**RE: Hurt Residence, Lot 11, Block 5 Unser Cliffs  
Grading and Drainage Plan  
Engineer's Stamp Date 10-1-14 (File: E10D025)**

**RE: Drainage Resubmittal  
Hurt Residence Lot 11, block 5 Unser Cliffs  
E10-D025**

ENGINEER'S SEAL <b>DAVID SOULE</b> NEW MEXICO REGISTERED PROFESSIONAL ENGINEER #14522	LOT 11, BLOCK 5 UNSER CLIFFS SUBDIVISION	DRAWN BY JDC
	GRADING AND DRAINAGE PLAN	DATE 07-06-2014
	<i>Rio Grande Engineering</i> 1606 CENTRAL AVENUE SE SUITE 201 ALBUQUERQUE, NM 87106 (505) 872-0999	SHEET # 1 OF 1
10/01/14 DAVID SOULE P.E. #14522		JOB #

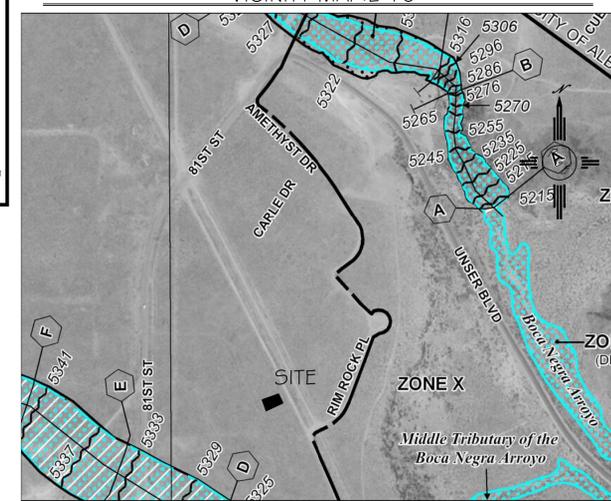
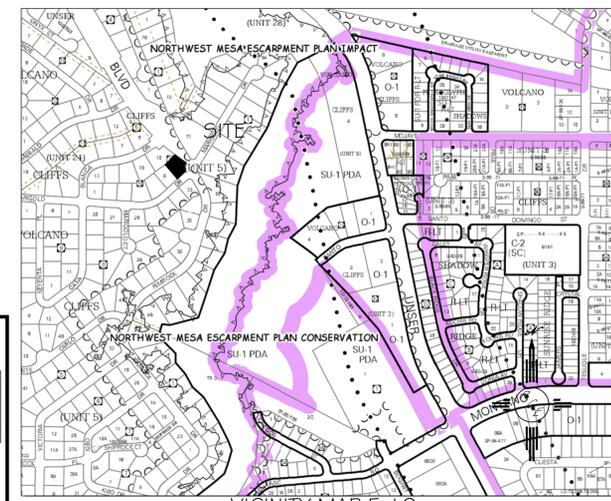
1. Existing contours too light  
**We have darkened**
2. Indicate zone page  
**We have added**
3. provide existing and proposed drainage calcs  
**We have added**

4. Provide drainage narrative  
**We have added**
5. quantify offsite flows  
**We have added on the calculation chart**
6. indicate contributing area  
**We have attached the map, the limits based upon city 2' contours, but we were not able to print out that for format, so we drew on google earth print out.**

7. Show easements.  
**All easements are shown**
8. Turn blocks only on the northeast side. Prove rundown  
**We have added the turned blocks only on northeast side. We have added narrative regarding how offsite flow is handled. The total flow leaving the site is less than existing**

9. Consider draining to marigold  
**Due to roof height restrictions, We are not able to raise the finished floor enough to drain over the top of curb.**
